**ADDENDUM #4  
TO THE  
SPECIFICATIONS AND CONTRACT DOCUMENTS  
FOR**

**Camas TO4 Ultraviolet Disinfection Replacement  
City Project No. SWR25004**

May 22,2025

EQUIPMENT BUILDING  
ARCHITECTURAL SCHEDULES

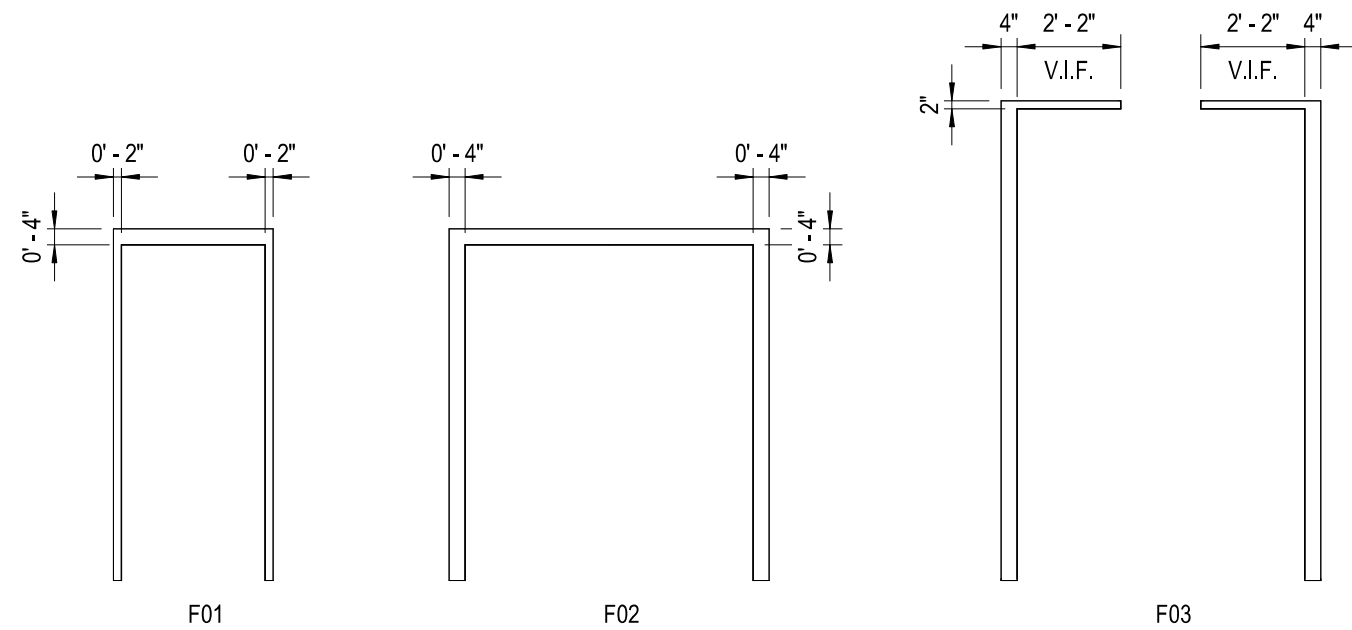
- 1. Drawing 011A-601 – Equipment Building Architectural Schedules
    - i. Materials for Overhead Coiling Doors 104 and 108 are revised to ALUMINUM.

3.01 Drawing 011A-601 - Equipment Building Architectural Schedules

A.Drawing is removed and replaced with the attached.

104	BIOFILTER FAN ROOM				6'-8"	7'-4"	0'-0 3/4"	D	ALUM	PAINT	NA		MET	PAINT	7/011A-602	8/011A-602				OVERHEAD COILING DOOR
108	GENERATOR ROOM				6'-8"	7'-4"	0'-0 3/4"	D	ALUM	PAINT	NA		MET	PAINT	7/011A-602	8/011A-602				OVERHEAD COILING DOOR
